STATE OF CONNECTICUT  
CONNECTICUT SITING COUNCIL

APPLICATION OF MESSAGE CENTER  
MANAGEMENT, INC. (MCM) AND NEW CINGULAR  
WIRELESS (AT&T) FOR A CERTIFICATE OF  
ENVIRONMENTAL COMPATIBILITY AND PUBLIC  
NEED FOR THE CONSTRUCTION, MAINTENANCE  
AND OPERATION OF A TELECOMMUNICATIONS  
TOWER FACILITY IN REDDING, CONNECTICUT

DOCKET NO. 449

RESPONSES OF MESSAGE CENTER MANAGEMENT  
AND NEW CINGULAR WIRELESS  
TO CONNECTICUT SITING COUNCIL PRE-HEARING QUESTIONS, SET I

## Model HPA-65R-BUU-H8

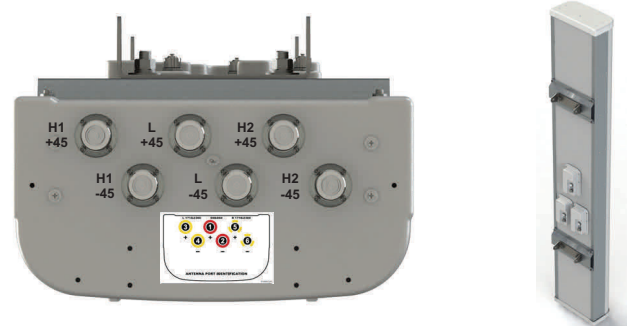
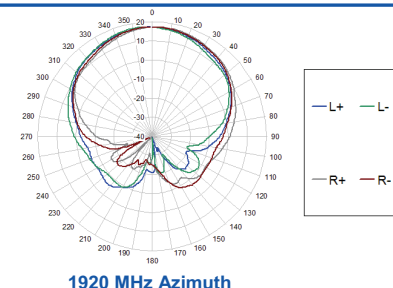
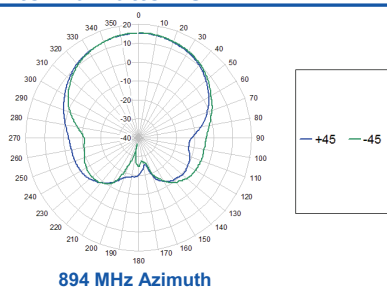
Q13. Proposed specifications sheet(s) for the proposed antennas.

A13. *Please see the attached specification sheet for AT&T's panel antennas (CCI HPA-65R-BUU-H8).*

ATTACHMENT 4

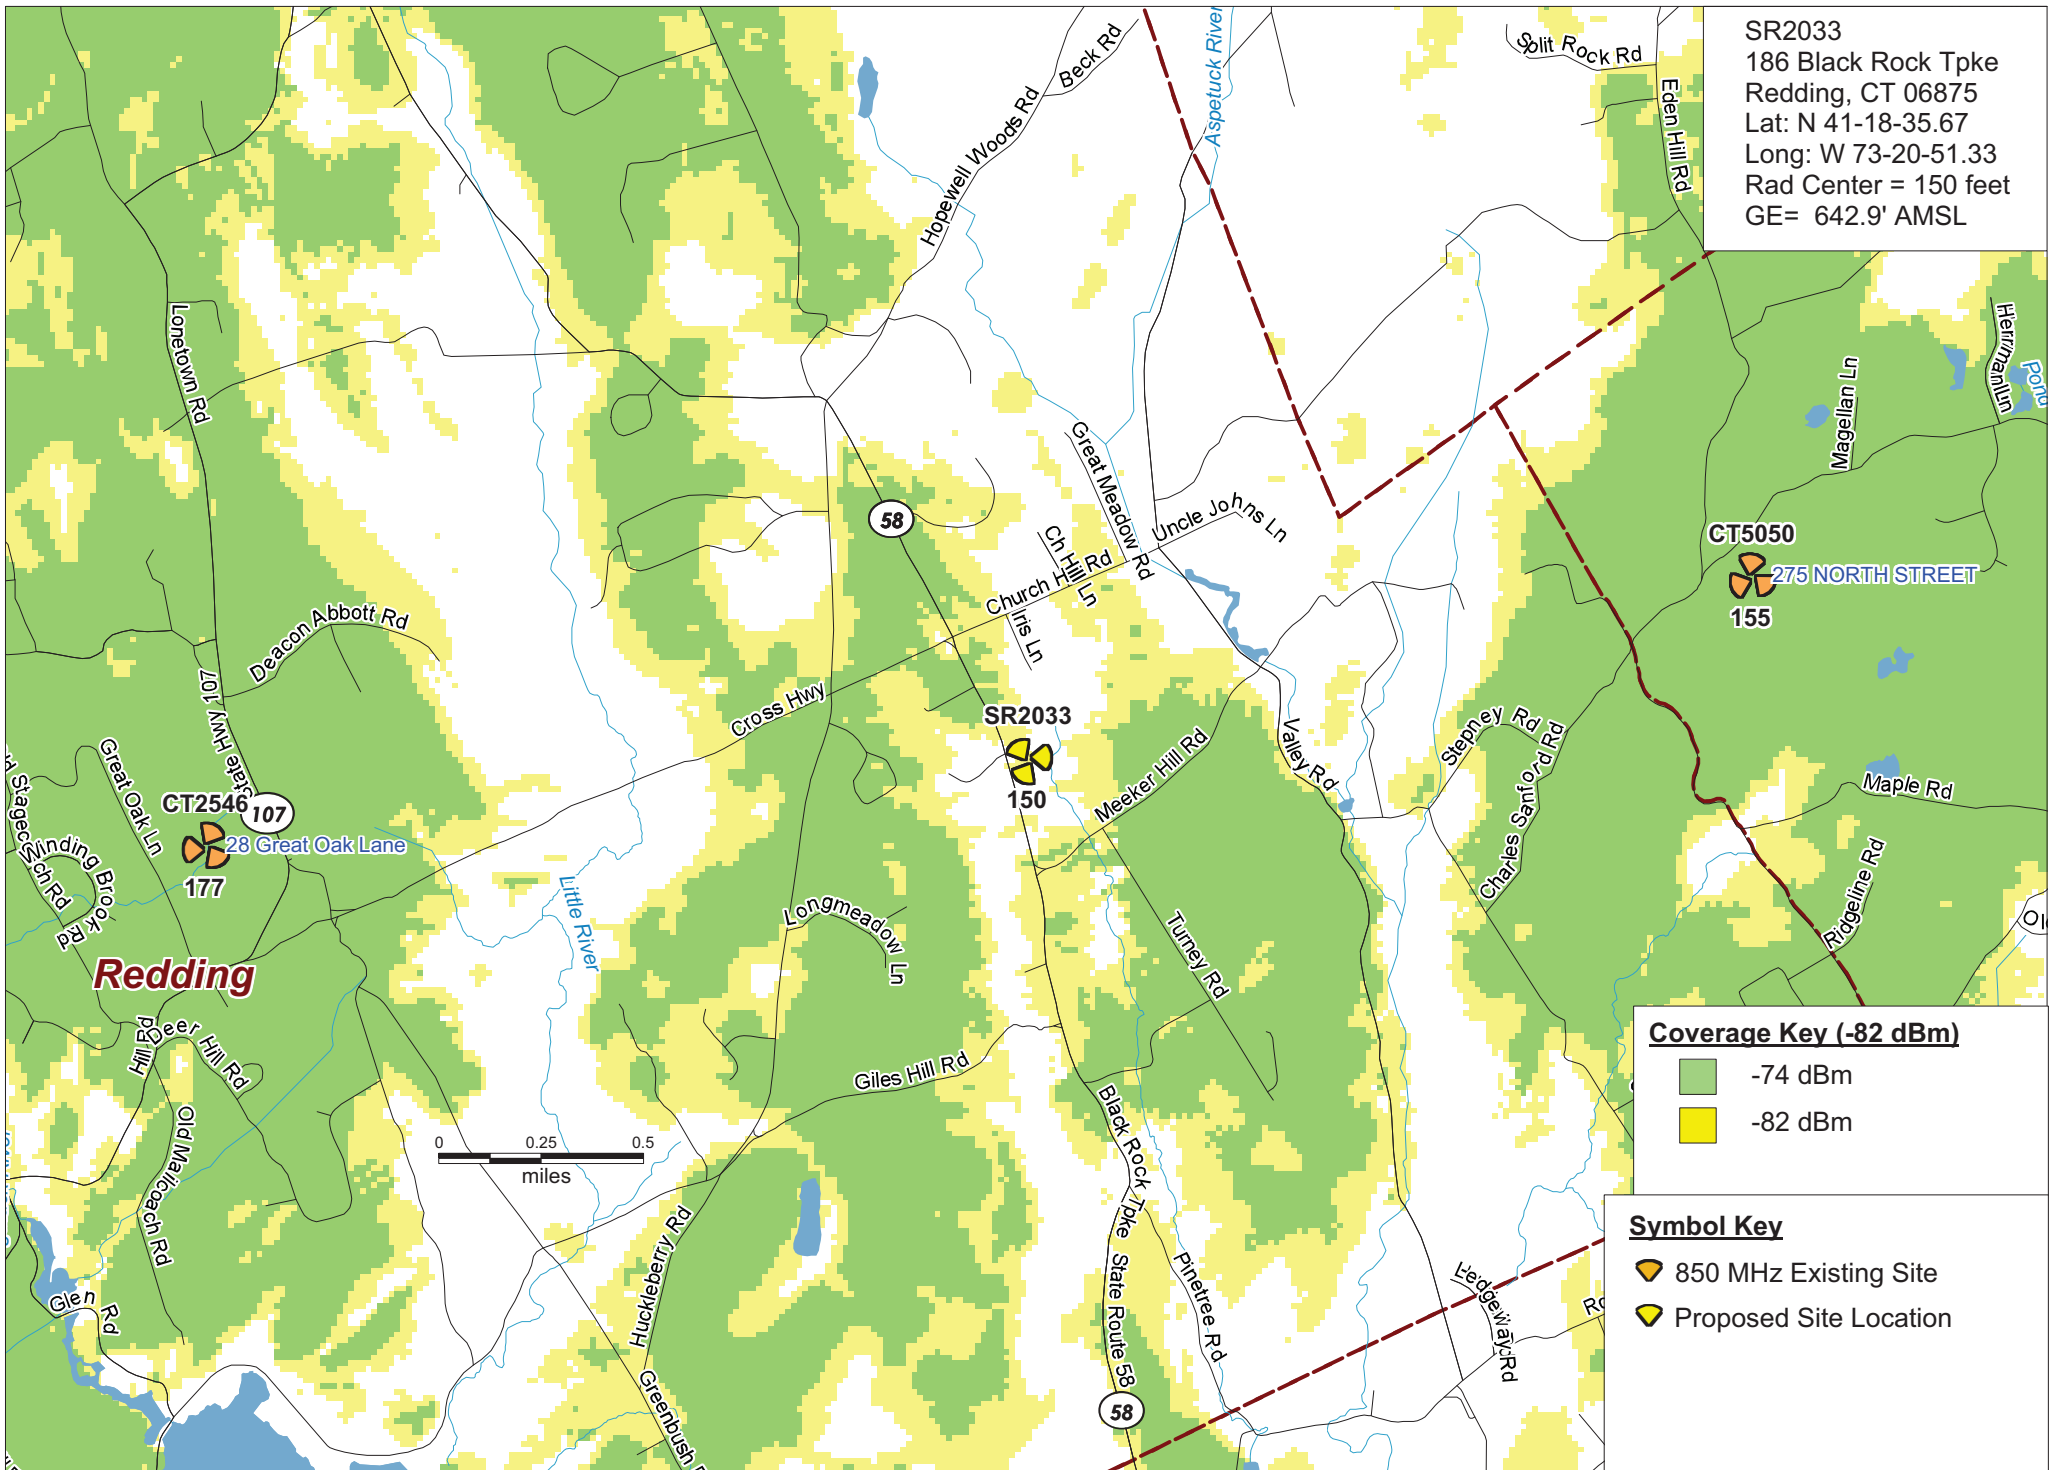
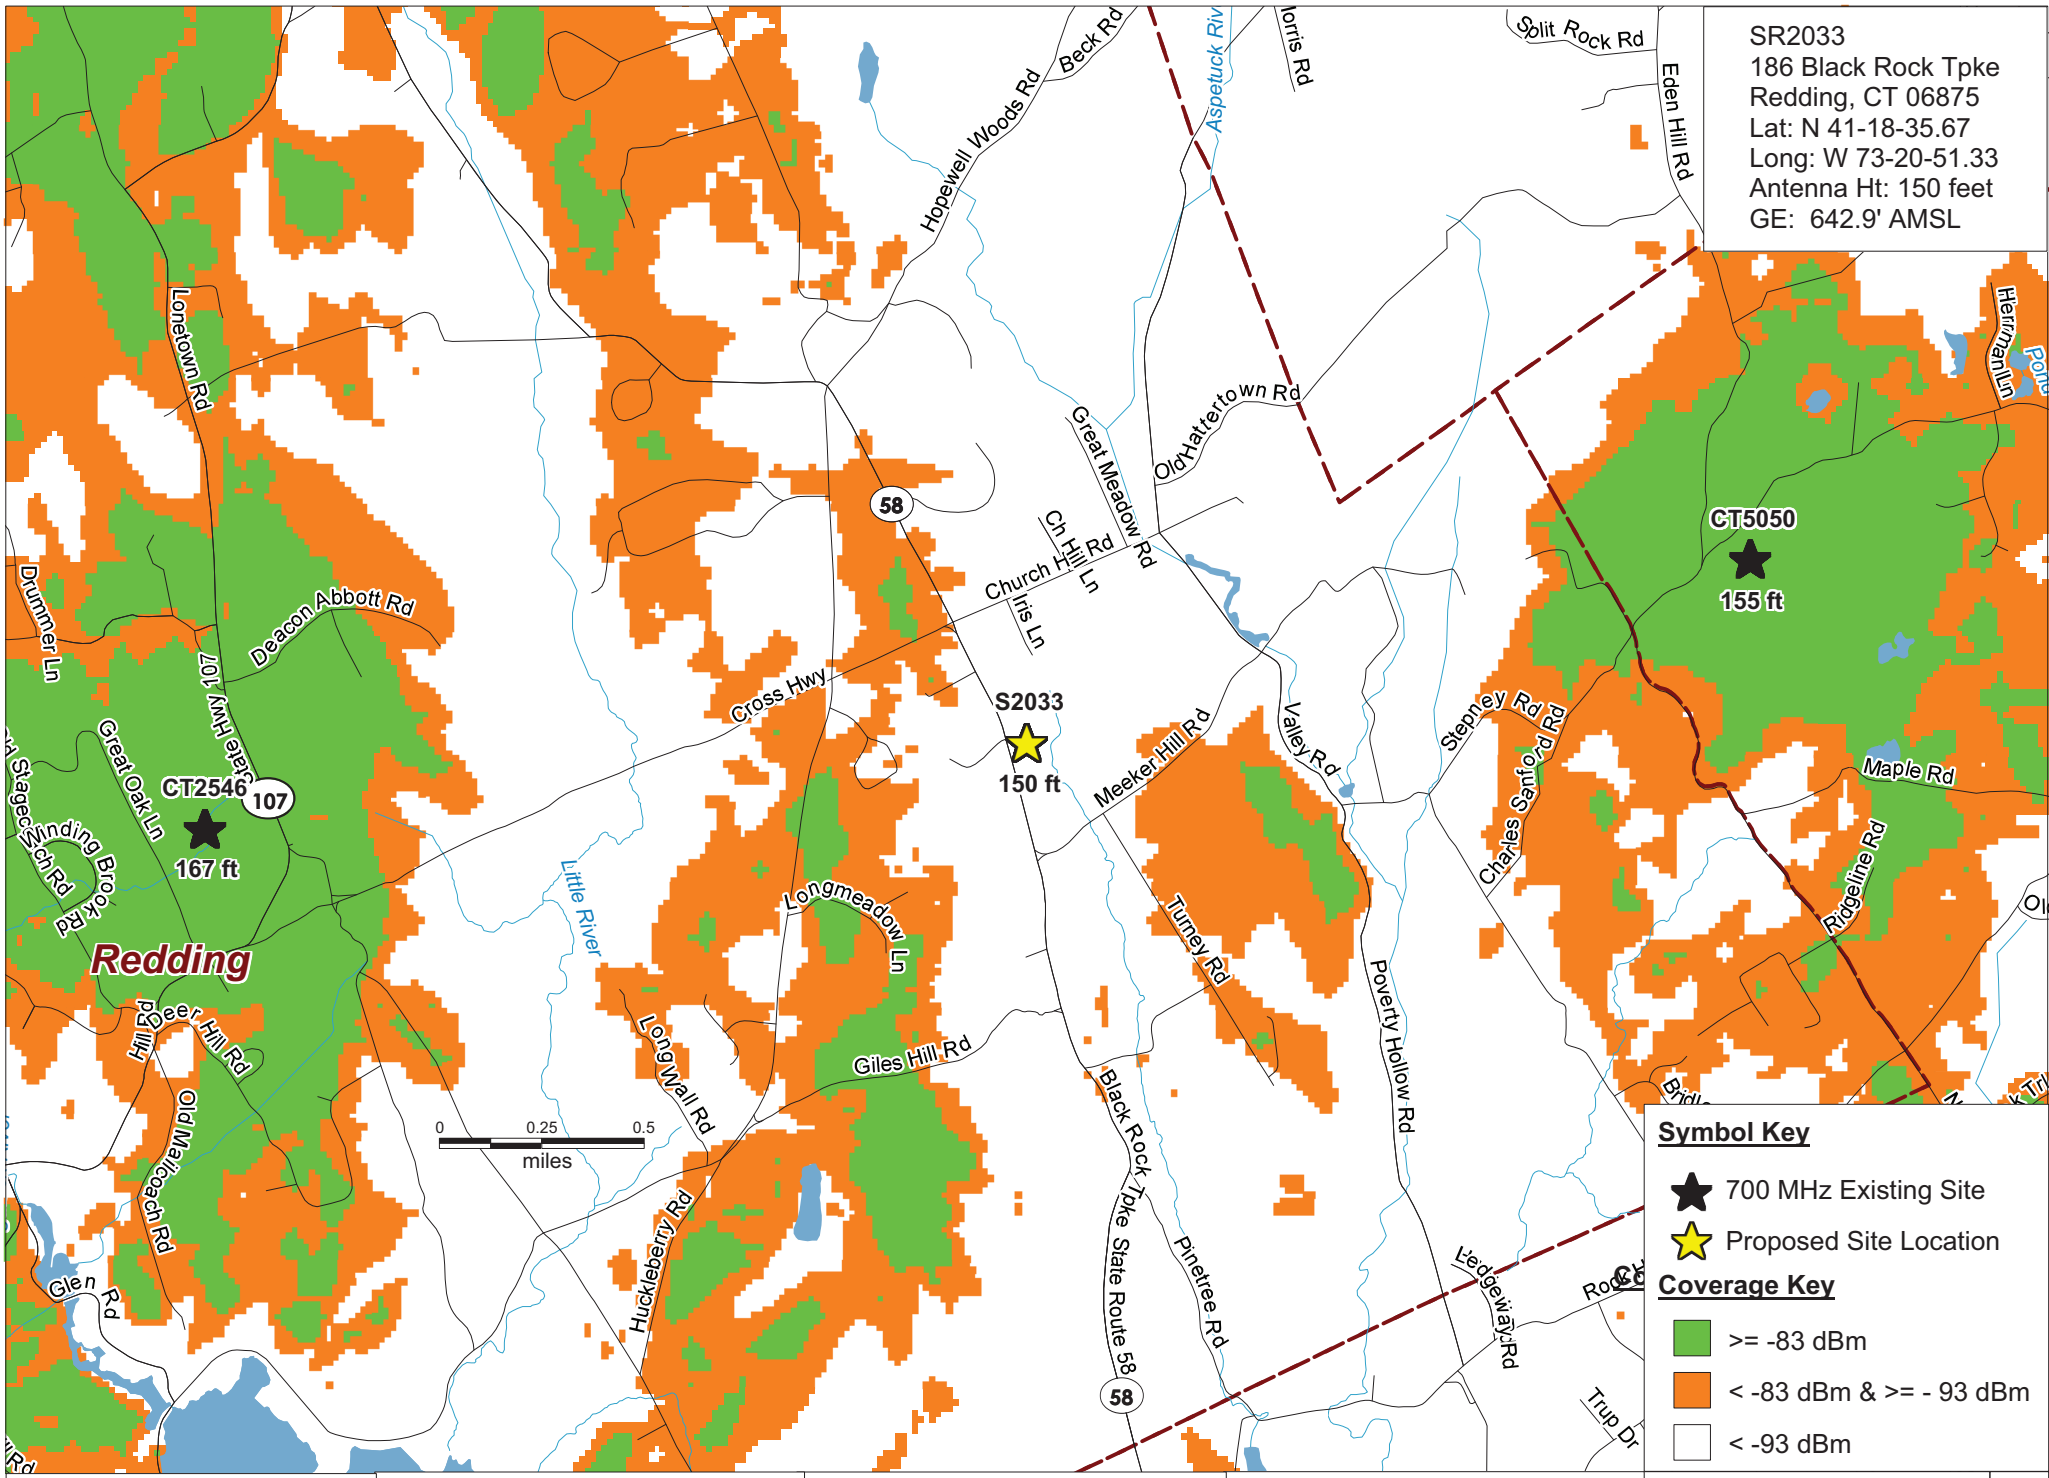
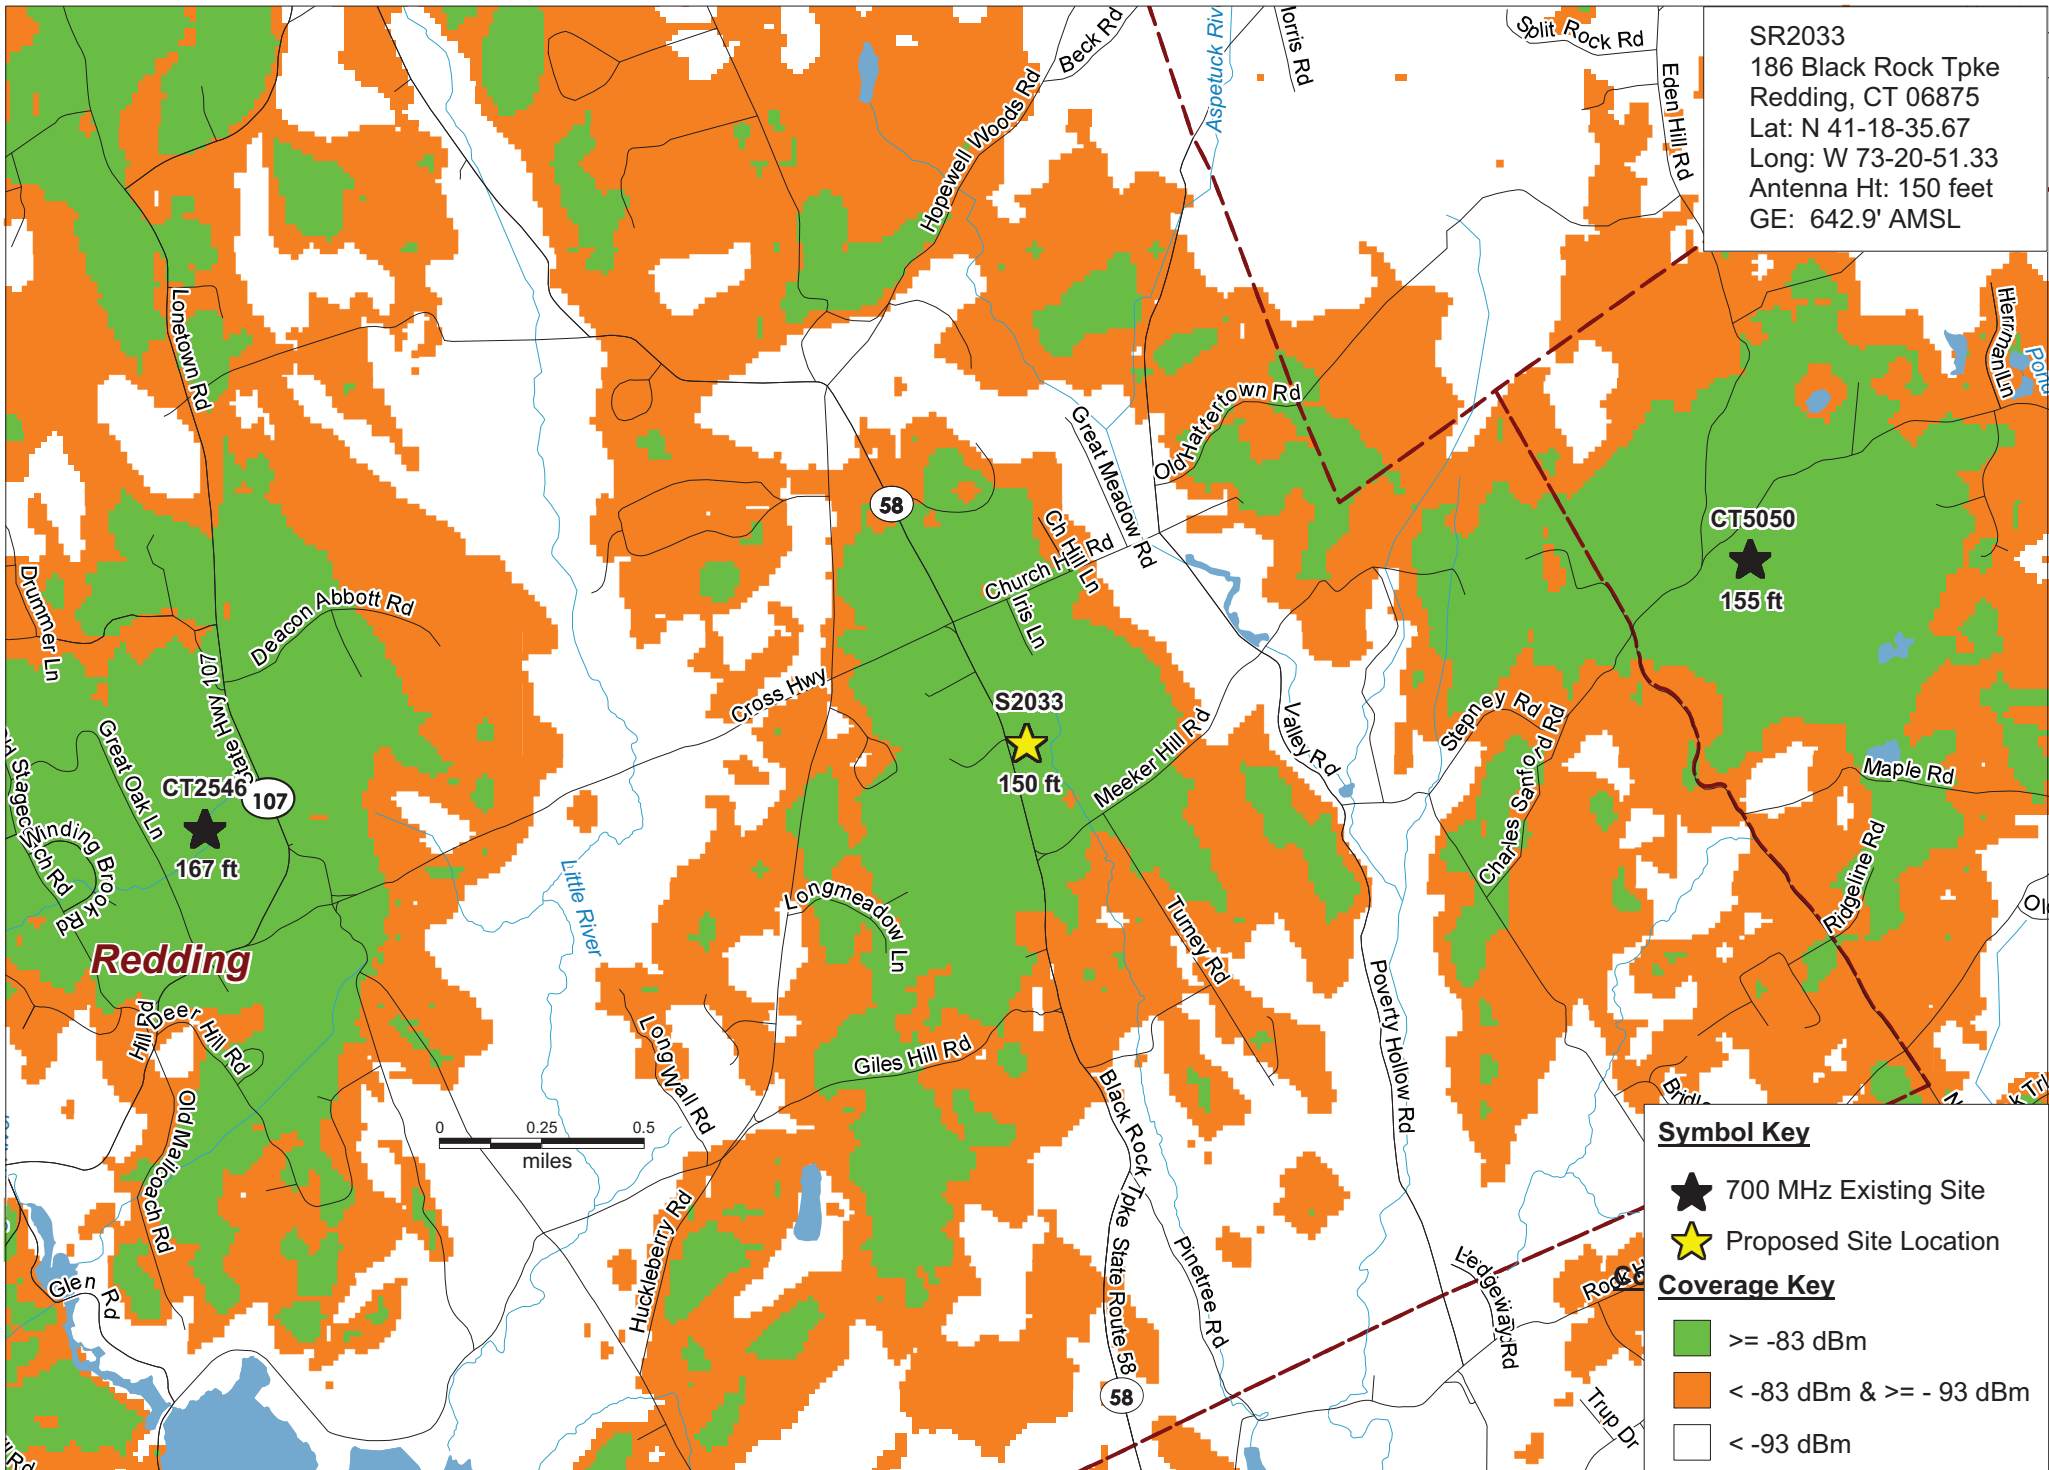
- Q27. In the Radio Frequency Analysis Report (RF Report) under Tab 1 of the Application, AT&T included an existing coverage plot and an existing and proposed coverage plot for 850 MHz. Provide a similar plots for 700 MHz and 1900 MHz or other frequencies as applicable. Also provide a replacement existing coverage plot for 850 MHz identifying the proposed site location on the plot.

- A27. *Please see plots included in Attachment 4.*
